FACT SHEET

OIL AND GAS GEOTECHNICAL SURVEYS AND RELATED ACTIVITIES IN FEDERAL WATERS OF THE BEAUFORT AND CHUKCHI SEAS (AKG-28-4300)

EPA RE-PROPOSES NPDES GENERAL PERMIT ISSUANCE

FIGURE 1: Chukchi Sea Spring Lead System Seasonally Restricted Area (see Permit Part II.A.6.)

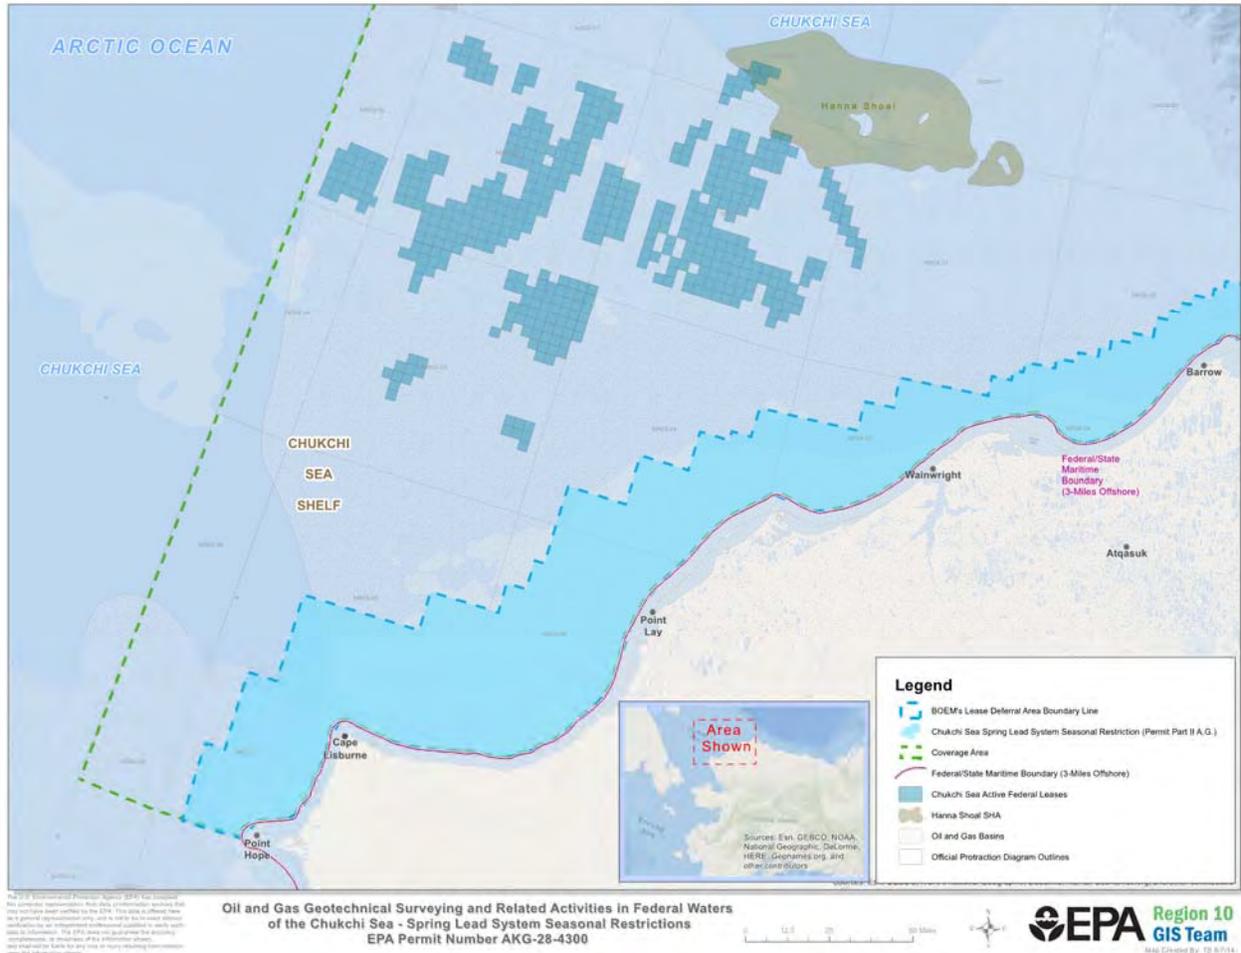
EPA received many comments on the importance of the spring lead system in the Chukchi Sea for migrating bowhead whales and for other marine mammals such as beluga and humpback whales and bearded seals, as well as certain bird species. Having reviewed those comments, EPA has included a prohibition of all discharges to federal waters of the Chukchi Sea within the area 3 to 25 nautical miles offshore prior to July 1. This prohibition is protective of the spring lead system, described further below, and the species that rely on it during the sensitive spring migration, feeding, and calving period.

This seasonal prohibition for the Chukchi Sea spring lead system is shown in FIGURE 1 (“Figure 2” in the Permit), below, and has been added to Permit Part II.A.6. (“Requirements for All Discharges”) and states as follows:

Chukchi Sea Spring Lead System Seasonal Restriction (Permit Part II.A.6.). The permittee is prohibited from discharging any waste stream within the Chukchi Sea lease deferral corridor, which corresponds to the area 3-25 nautical miles offshore, prior to July 1. Figure 2 (below) provides a map of where this seasonal restriction applies.
